30/06/2026
Att: Planning
Glenorchy City Council

PLN-26-133
51 Faulkners Rd, Glenlusk

In response to your correspondence dated 24/06/2026
I have addressed your requests as follows:

BUSHFIRE ASSESSMENT REPORT

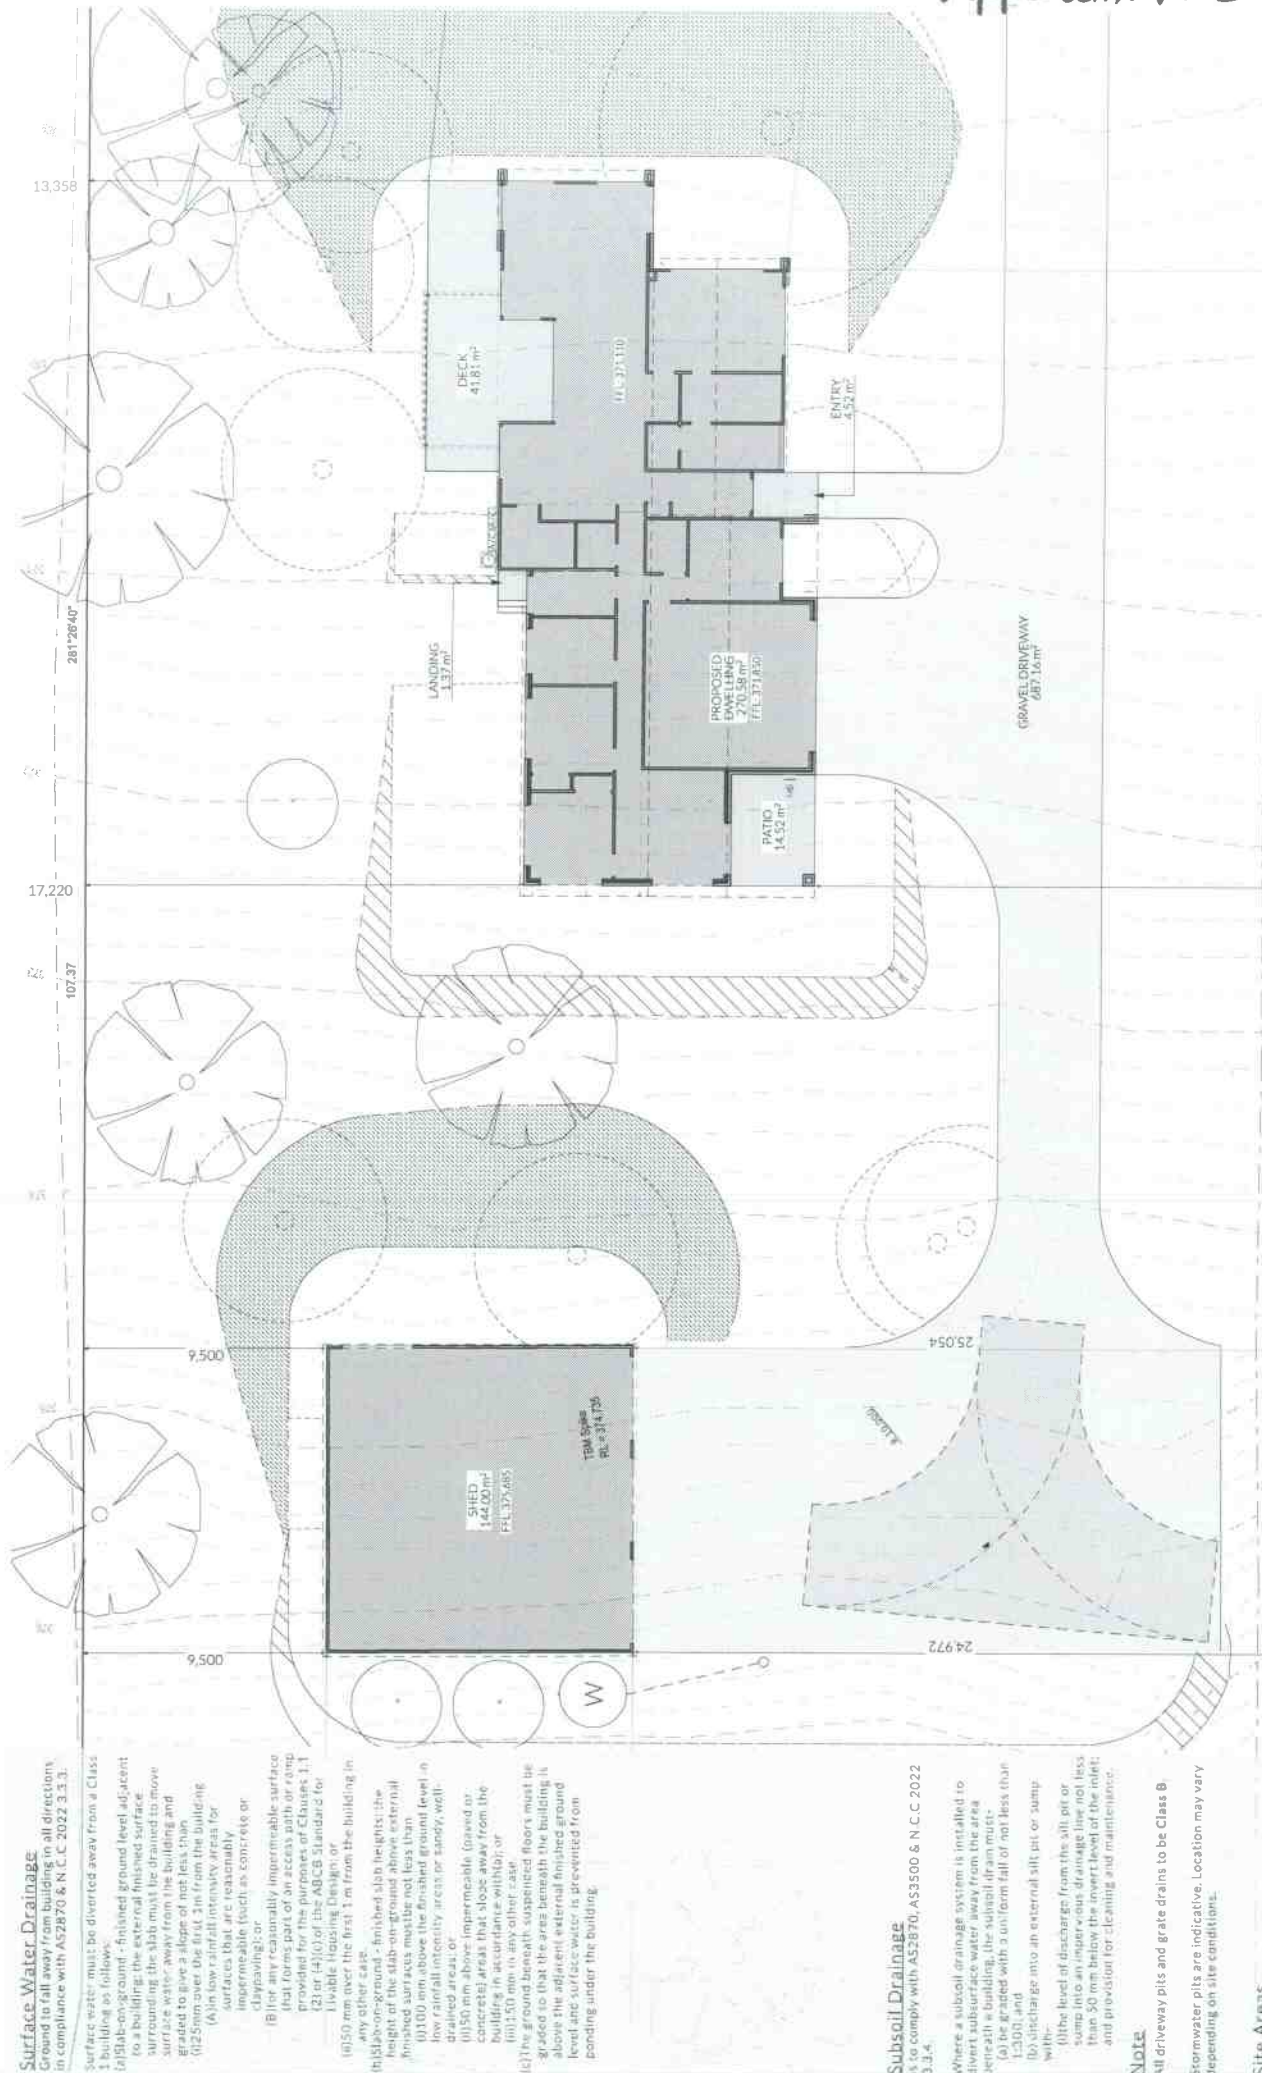
ITEM	COUNCIL REQUEST	DEVELOPMENT RESPONSE
1	<i>A bushfire management plan is required to be submitted, so the driveway requirements can be assessed</i>	Please Refer to Bush fire report
2	<i>The car parking space dimensions to demonstrate compliance with the requirements in Table C2.3; and</i>	Please refer to the amended drawings (pg.no A.02) showing a 4 m wide driveway complying with page 15 of the attached bushfire report, with car parking provided internally within the garage.
3	<i>A vertical clearance of not less than 2.1m above the parking surface level for the garage.</i>	As shown in floor plan and site plan P1 & P2 are to be located within the garage. Noted CH: 2400mm Please refer to (pg.no A.02 & A.03)
